**Subject:** 5P50 (early Production) - Snap Ring, 70-0400 eliminated

UNITS AFFECTED: 5P50 Titan Series (early production)

**FIG 1**  
"IS" Snap Ring for the crankshaft main bearings is eliminated.

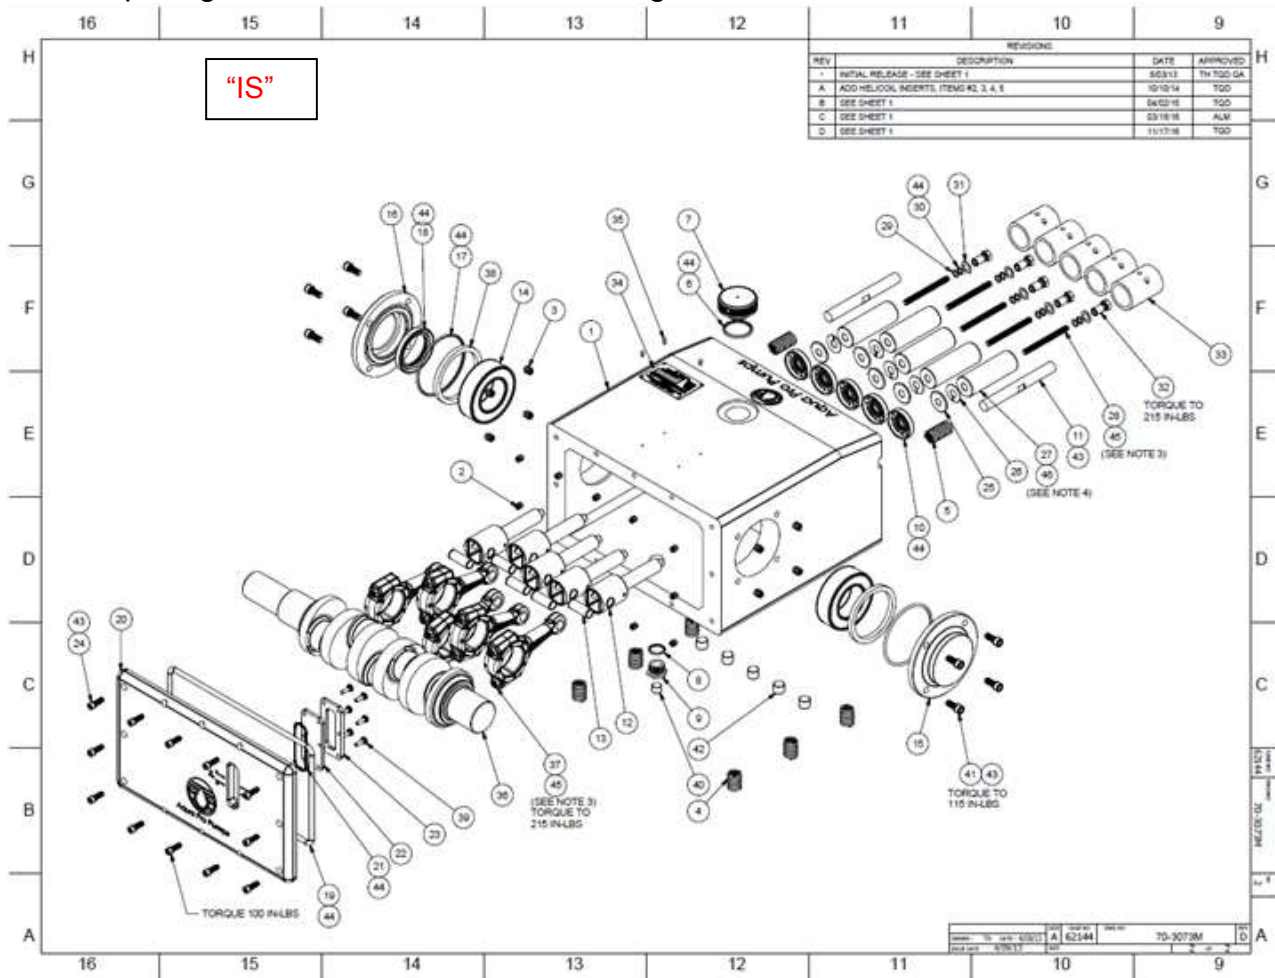
This technical bulletin is to document the elimination of part number 70-0400, snap ring from the 5P50 crankcase assembly. The crankcase has been modified with a stepped crankshaft main bearing housing bore. The stepped bore keeps the bearing from moving axially along the bearing bore thus eliminating the need of a snap ring for bearing retention.

FIG 2

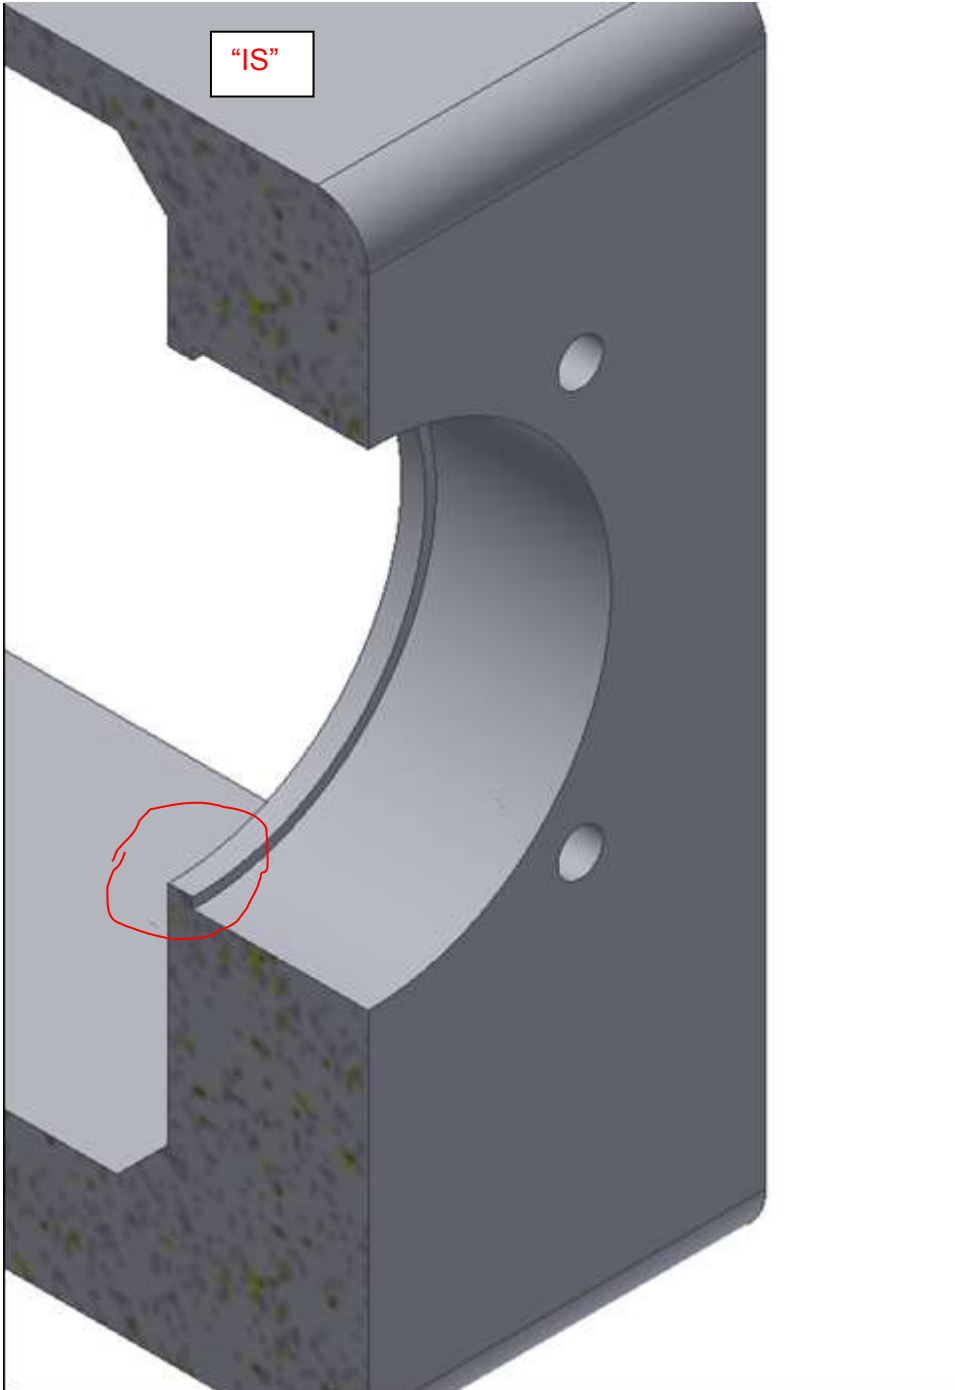
"IS" Cross section view of current crankcase (70-3082M) design showing the step in the main bearing bore.

FIG 3

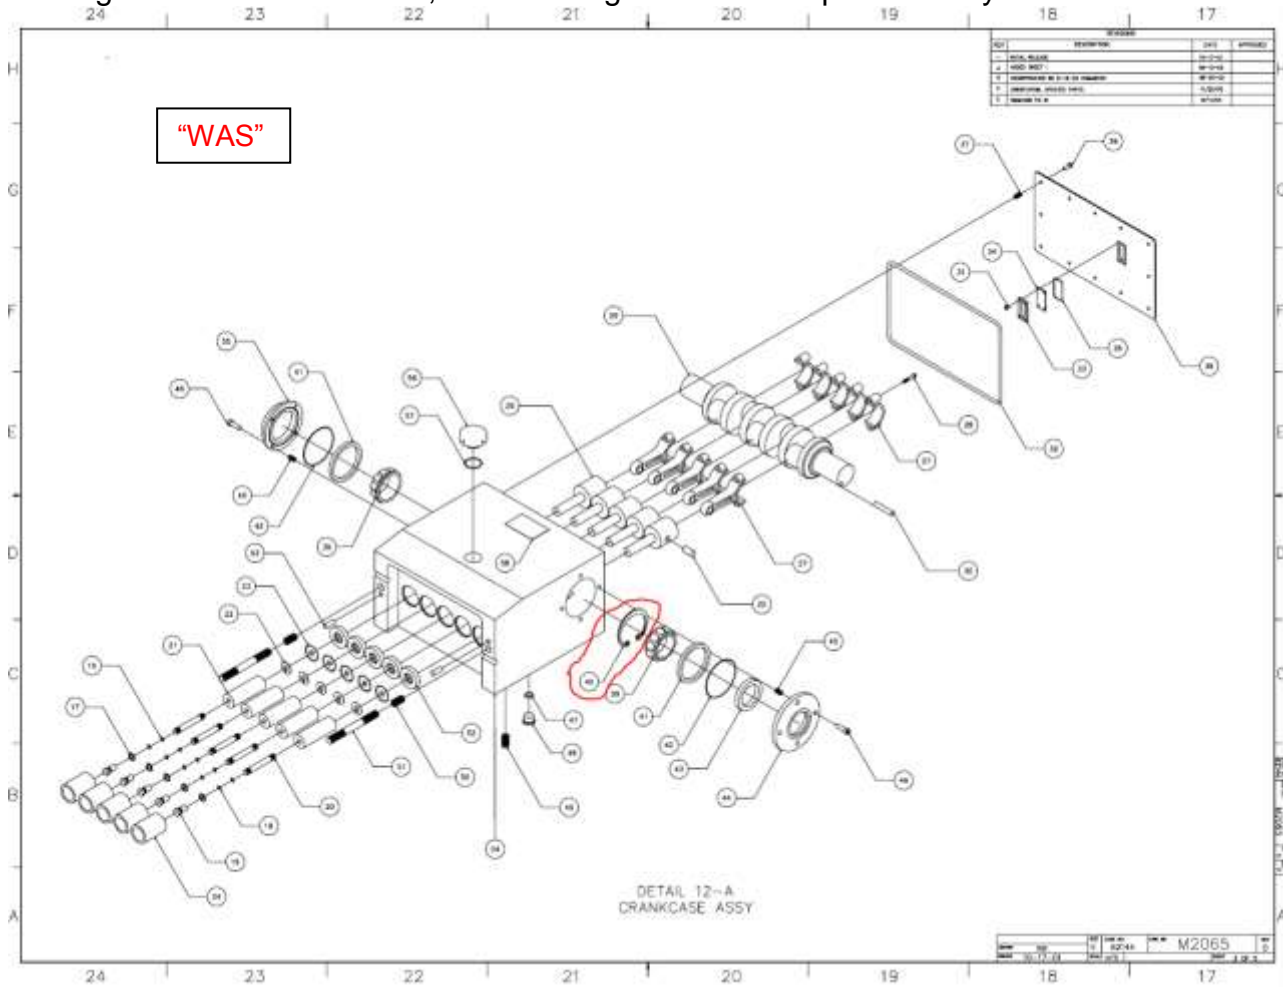
“WAS” The old style crankcase, (no longer available) and snap ring, 70-0400. Drawing M2065 is no longer used for Production, The drawings has been superseded by 70-3000M.
